**Subject: Response to Data Request for Reclamation and Closure Plan Clarifications**

**Resolution Copper Response to Tonto National Forest request for clarifications on the Draft Reclamation and Closure plan**

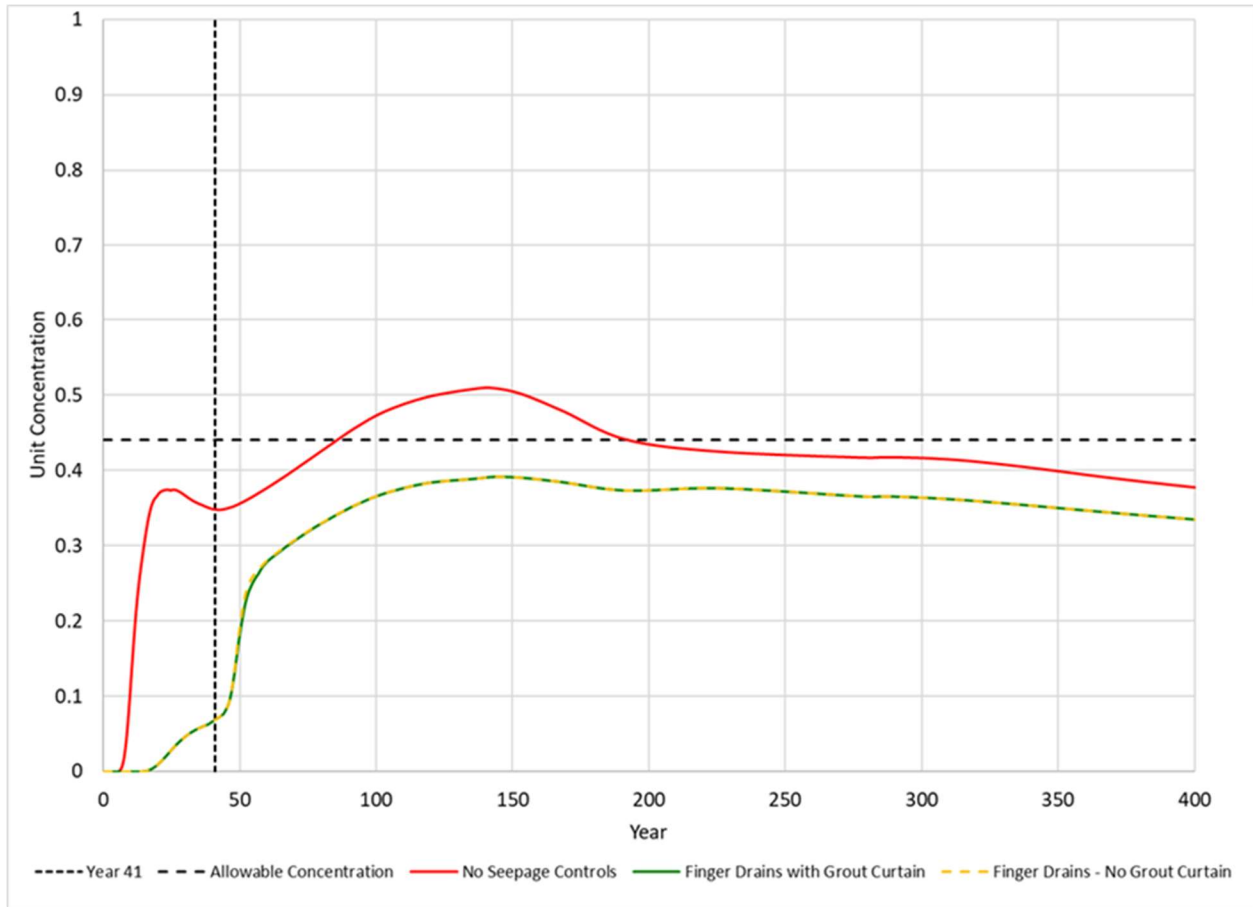
**RCL-6. Specific Post-Closure Impact Analysis.** Related to potential failure mode N-2, a specific concern raised during the final water resources workgroup meeting (July 30) was the impact to downgradient groundwater quality if and when the grout wall is removed, i.e., downgradient release of poor-quality groundwater. We intend to analyze this impact in Section of the FEIS. To do so:

- We feel adequate information exists to estimate to groundwater quality at this location at the point in time the grout curtain is breached. Specifically, Appendix B of the July 2020 Montgomery & Associates modeling report includes concentrations of contaminants at years 41, 143, and 441, at varying distances downstream from the main embankment.
- We are seeking input on the best way to estimate the transport of this groundwater when the grout curtain is breached, and specifically whether the groundwater model can be used to estimate this scenario.

**Response:** *The plot below shows predicted unit concentrations with the grout curtain and without the grout curtain. Concentrations without the grout curtain are only slightly different from those with the grout curtain. This is primarily because the alluvial pumpback wells prevent a significant buildup of heads in front of the dam in both scenarios. If the grout curtain was removed post closure, it would not be expected to have a significant impact on predicted concentrations.*
